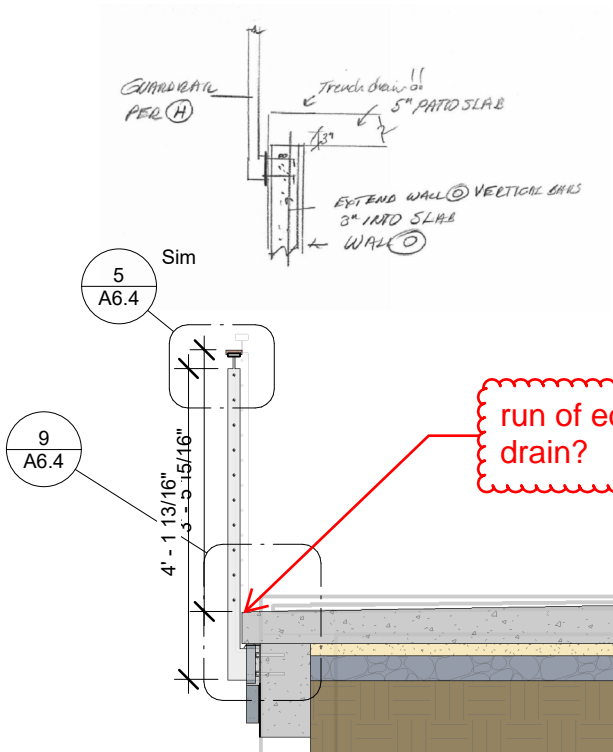
overflow scuppers along here

w/ 1% slope, there's not much room for a channel drain. That okay?

Also, is the downspout in the wall, for this, or will it be exposed?

try slot drain just on outside of beam line. DS in wall, with overflow scuppers in parapet wall

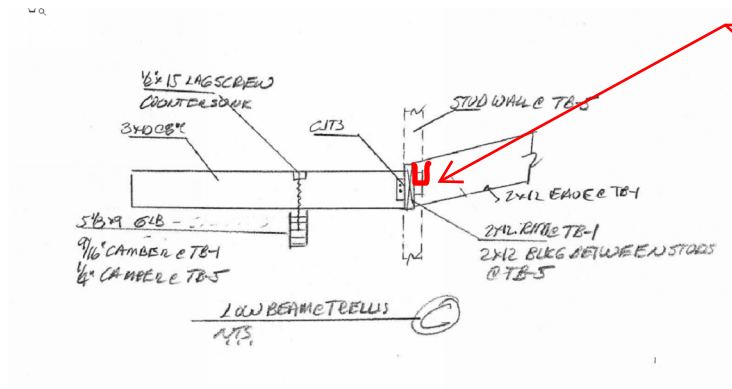
run of edge or trench drain?

radiant heat in floor?

if so, everywhere throughout 1st floor?

with a concealed gutter, this structural connection might be a little tenuous.

structural engineer thinks it will be okay to cut into these rafter tails with the gutter. Please propose the detail and we'll run it past them, thanks!
